Access Compliance Report

Public Rights-of-Way (Curb Ramps)

Intersection ID: N/A	Main Street: MARTIN_LUTHER_KING_JR_BV	Cross Street: N/A	Location: W
ADA ID: 9EF9449E20F2	Ramp Type: BlendTrans1	Initial Pass/Fail: Pass	Overall Compliance: No
Severity Score: 0.25			
Codes/Mitigation Info/Possible Solution		Field Measurements/Component Compliance

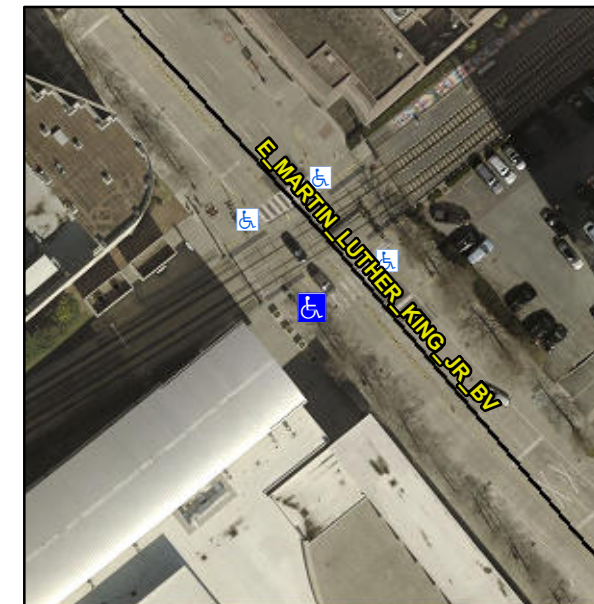
R304.5.3

Compliance	Description	Data	Compliance	Description	Data
N/A	Ramp Length (in)	70.0	Yes	BlendTrans Slope (%)	2.5
Yes	Ramp Width (in)	48.0	No	BlendTrans XSlope (%)	2.2
N/A	Flare Type LT	Sloped	N/A	Flare Type RT	Sloped
Yes	Flare Slope LT (%)	5.2	Yes	Flare Slope RT (%)	7.4
N/A	Flare Traversable LT?	Yes	N/A	Flare Traversable RT?	Yes
Yes	Landing Length (in)	48.0	Yes	DWS Provided?	Yes
Yes	Landing Width (in)	48.0	Yes	DWS Contrast?	Yes
Yes	Landing Slope (%)	0.1	Yes	DWS Length (in)	24.0
No	Landing X Slope (%)	2.7	Yes	DWS Full Width?	Yes
N/A	Landing Curb? (Y/N)	No	Yes	DWS Offset (in)	1.0
N/A	Shared Landing?	No			
Yes	Gutter Ponding?	No	Yes	Gutter Slope (%)	1.0
Yes	Gutter Lip Ht (in)	0.0	No	Gutter X Slope (%)	2.8
N/A	Painted X Walk1?	Yes	N/A	Painted X Walk2?	N/A
	X Walk 1 Direction	To E		X Walk 2 Direction	N/A
	X Walk 1 Width (in)	135.0		X Walk 2 Width (in)	N/A
	X Walk 1 Slope (%)	0.1		X Walk 2 Slope (%)	N/A
	X Walk 1 X Slope (%)	2.2		X Walk 2 X Slope (%)	N/A

Remove & Replace Curb Ramp With Two New Directional Ramps or Equivalent. Remove & Replace Gutter.
